## Process Sheet

Customer: CU-DAR001 Dart Helicopters Services

Drawing Name: ARM

Part Number: D3560042

B	07.01.15	REDESIGN AS WELDMENT, ADD POCKETS
A	06.09.25	NEW ISSUE
DESIGN	97	DRAWN BY
CHECKED	4	APPROVED
DATE		07.01.15
TITLE		ARM WELDMENT
DRAWING NO.		D3560
SHEET 1 OF 3		SCALE
DART AEROSPACE LTD., HANDBURY, ONTARIO, CANADA

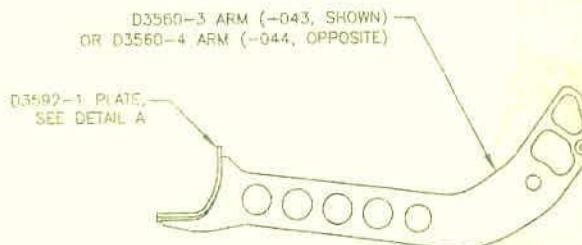
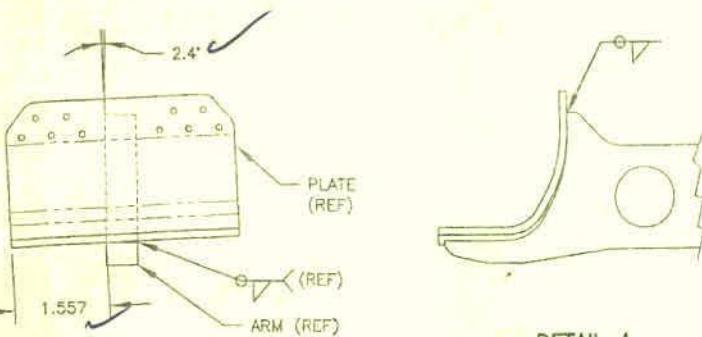
W/O:		WORK ORDER CHANGES						
DATE	STEP	PROCEDURE CHANGE	By	Date	Qty	Approval Chief Eng / Prod Mgr	Approval QC Inspector	
07.06.06	11	NO POWDER COAT. CHEM CONV. COAT ONLY. REF ATTACHED DS EMAIL				QP 07.06.06 per QSI 042	J 07-06-07

For the D3562-041/-042 step weldment, as discussed. They want to switch from Sikaflex to Magnabond, and powder coat after final assembly.

As part of this change, the D3560-XX arms won't be powder coated, and the D2808 Bushing won't be assembled until after final assembly of the step weldment.

Since this is the first time trying this, we will ensure that the steps are checked after powdercoating in case the Magnabond doesn't anything unexpected (eg. bubbling). If we see anything suspect, we will assemble them the old way.

As we have discussed previously, this is acceptable as long as the Magnabond doesn't break down.
